RE: 30 Fairlight St, Fairlight

BCA COMPLIANCE STATEMENT FOR DA SUBMISSION

BALCONY

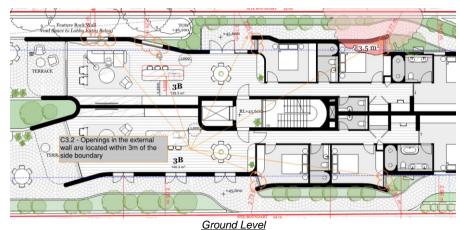
<u>Comment</u>: The following openings are exposed to the boundary and will need to be protected in accordance with BCA Clause C3.4 or otherwise addressed to the degree necessary by a fire Engineered Performance Solution.

- + <u>Basement Level</u> The roller shutter which provides vehicular access into the carpark and the doorway providing access to the pump room are located within 3m of the side boundary.
- + <u>Ground Level & Level 1</u> There are a number openings located in the eastern and western façade which are located within 3m of the side boundary.

C3.2 - Openings in the external wall are located within 3m of the [Iside boundary]
